60th Avenue Standpipe
 1015 60th Ave SW
 Cedar Rapids, IA 52404

Boyson Tank
 575 Boyson Rd. NE
 Cedar Rapids, IA 52402

Mt. Vernon Tank
4328 Mt. Vernon Rd. SE
Cedar Rapids, IA 52402

**J Avenue Water Treatment Plant -
Lime Sludge Tank
761 J Ave NE
Cedar Rapids, IA 52402**

PITT-DES MOINES, INC. ENGINEERS - FABRICATORS - CONTRACTORS	
WILSON AVE. TANK	
2000 M GAL. HYDROPILLAR	
CEDAR RAPIDS, IA.	
MAIN ERECTION	
DWG. PREPARED AT 31	FABRICATED AT 32
BY	DATE
DRAWN: M.B.	6-28-89
CHECKED: P.B.	8-8-89
DRAWING	E1
CONTRACT	59017

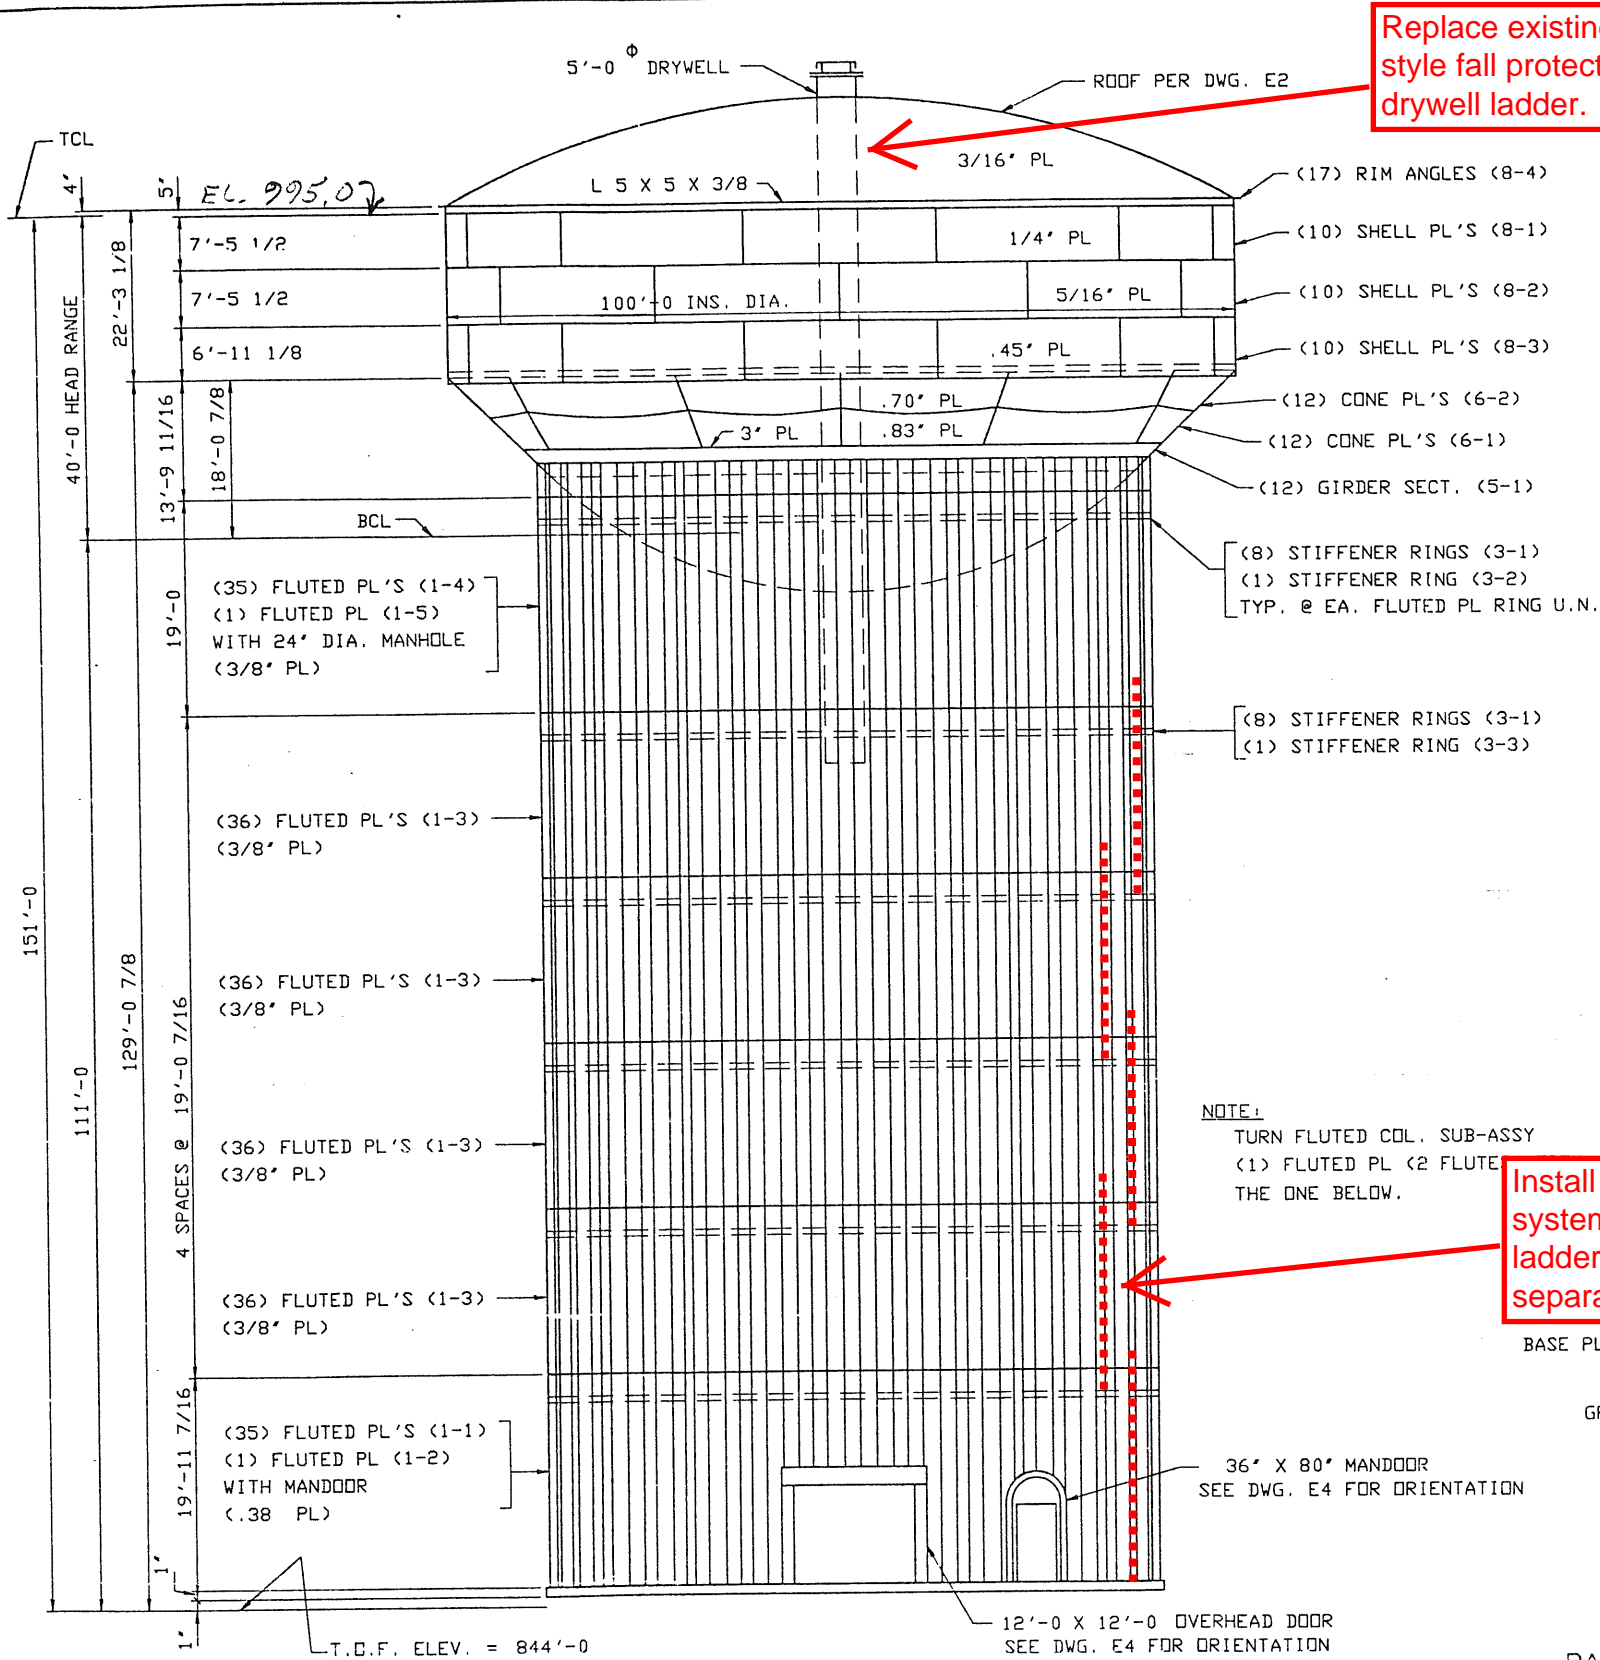
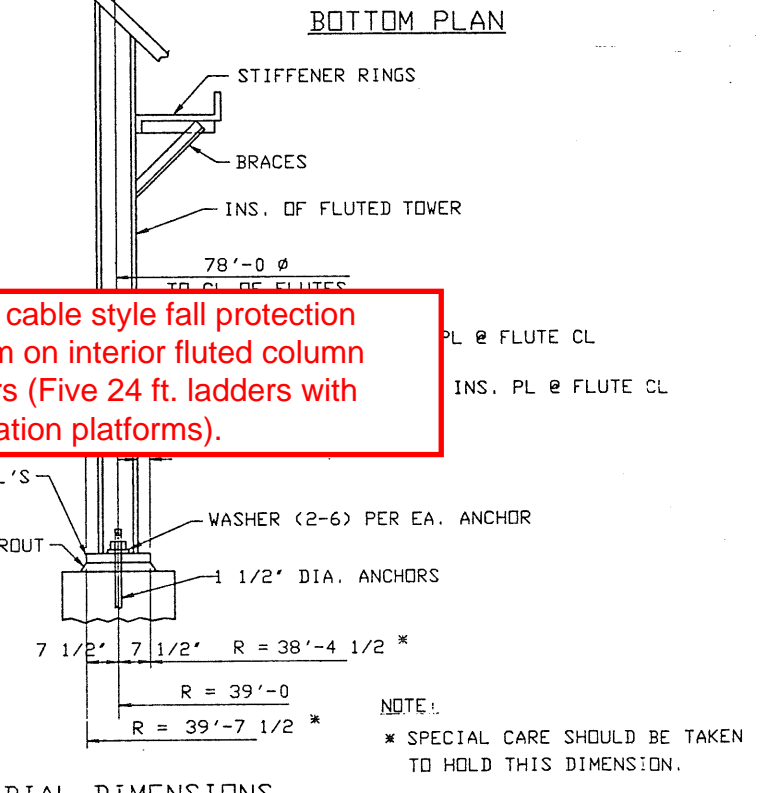
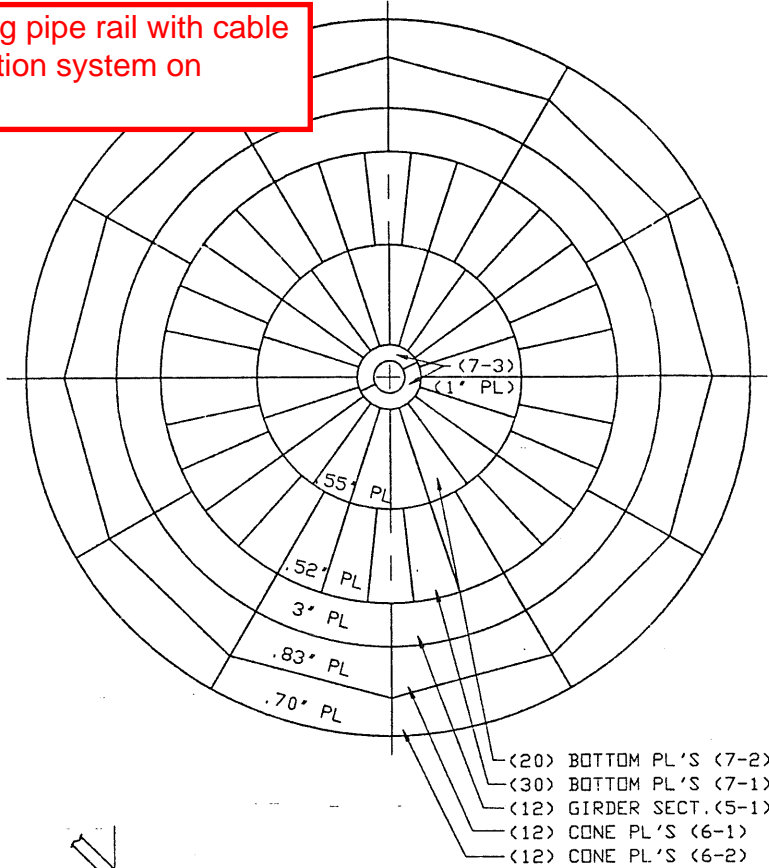
Replace existing pipe rail with cable style fall protection system on drywell ladder.

Install cable style fall protection system on interior fluted column ladders (Five 24 ft. ladders with separation platforms).

SLUDGE TANK SECTION
SCALE: 1/4" = 1'-0"

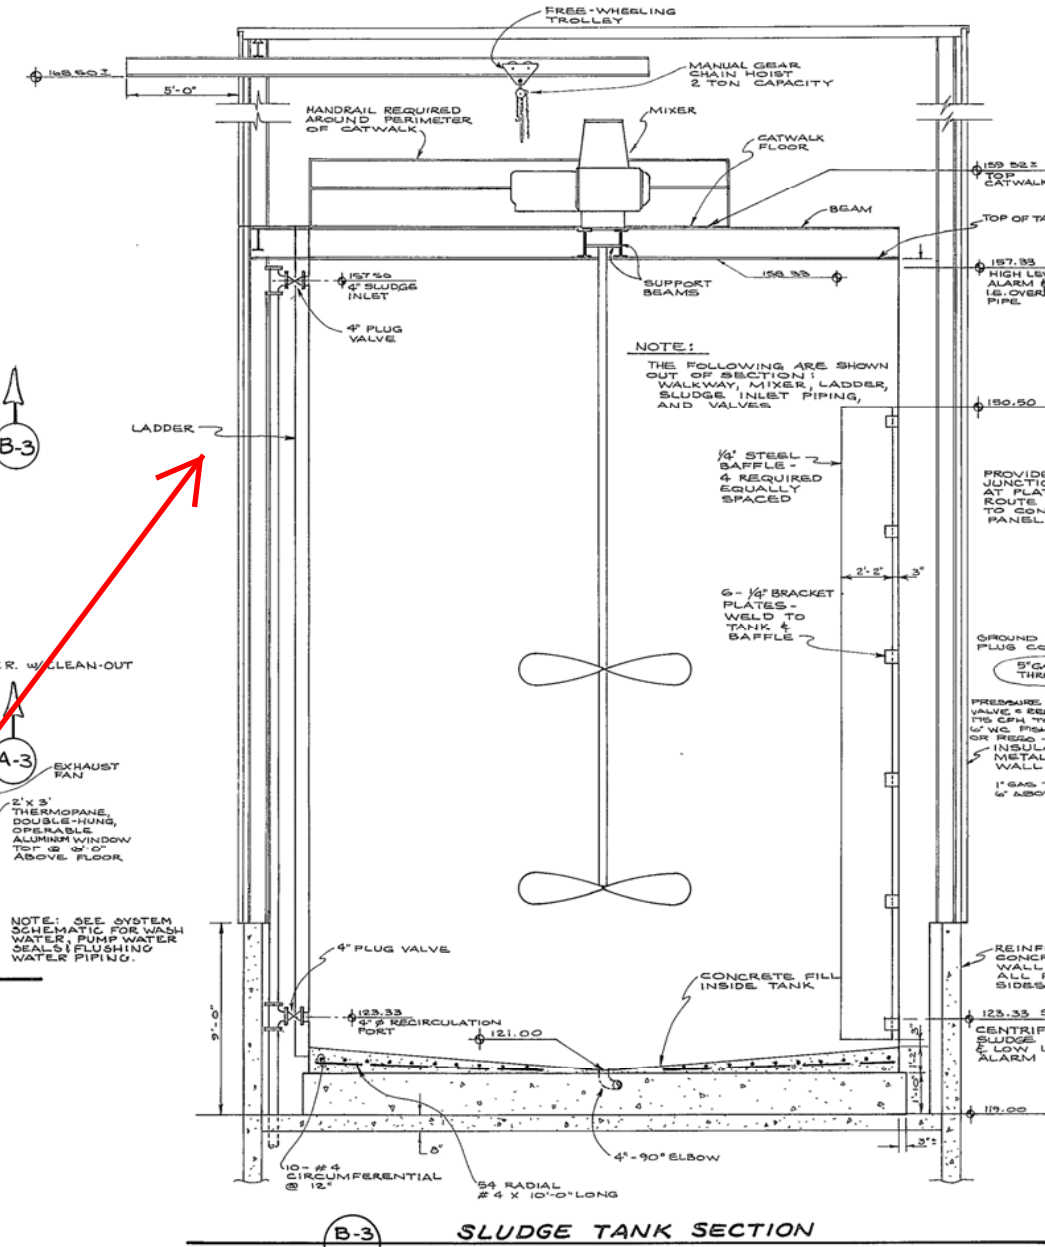
Replace existing pipe rail with cable style fall protection system on ladder (one ladder, approximately 40 ft. in height).
